Woden Village DA RFI – List of Changes:

EAST OFFICE BUILDING ELEVATION

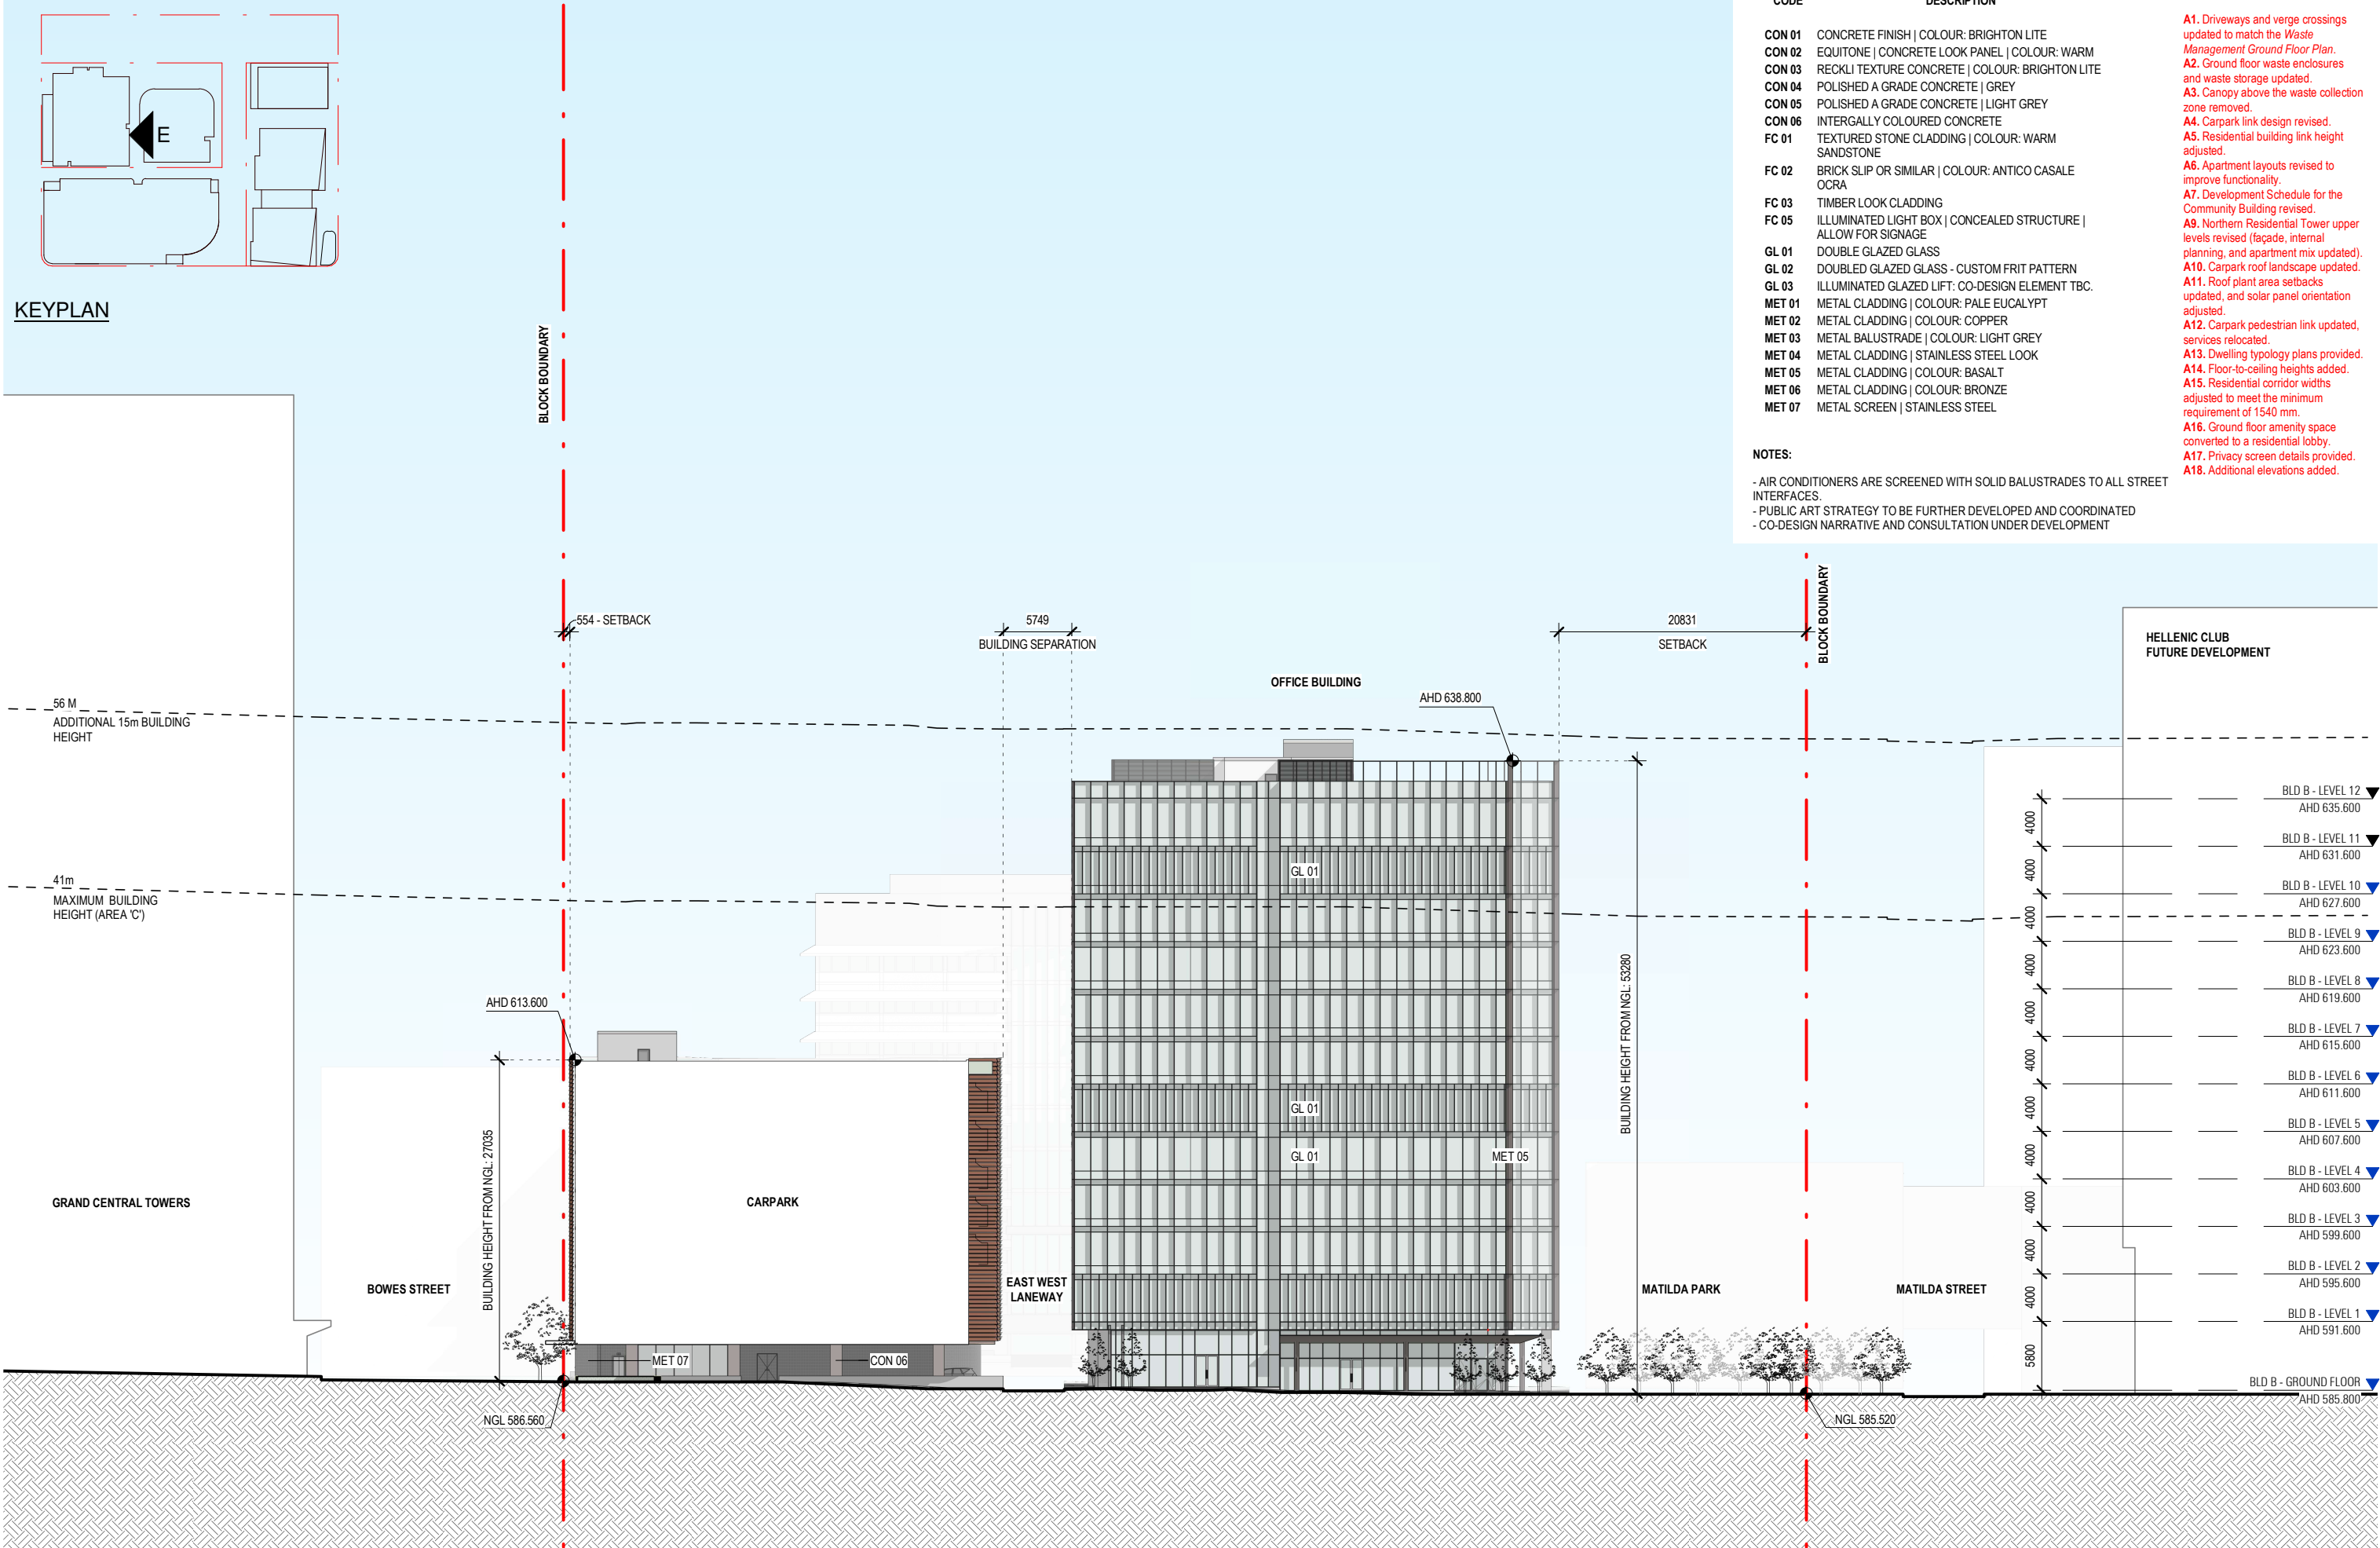
- A1. Driveways and verge crossings updated to match the Waste Management Ground Floor Plan.
- A2. Ground floor waste enclosures and waste storage updated.

- A3. Canopy above the waste collection zone removed.
- A4. Carpark link design revised.
- A5. Residential building link height adjusted.
- A6. Apartment layouts revised to improve functionality.

- A7. Development Schedule for the Community Building revised.
- A9. Northern Residential Tower upper levels revised (façade, internal planning, and apartment mix updated).

- A10. Carpark roof landscape updated.
- A11. Roof plant area setbacks updated, and solar panel orientation adjusted.
- A12. Carpark pedestrian link updated, services relocated.

- A13. Dwelling typology plans provided.
- A14. Floor-to-ceiling heights added.
- A15. Residential corridor widths adjusted to meet the minimum requirement of 1540 mm.

- A16. Ground floor amenity space converted to a residential lobby.
- A17. Privacy screen details provided.
- A18. Additional elevations added.
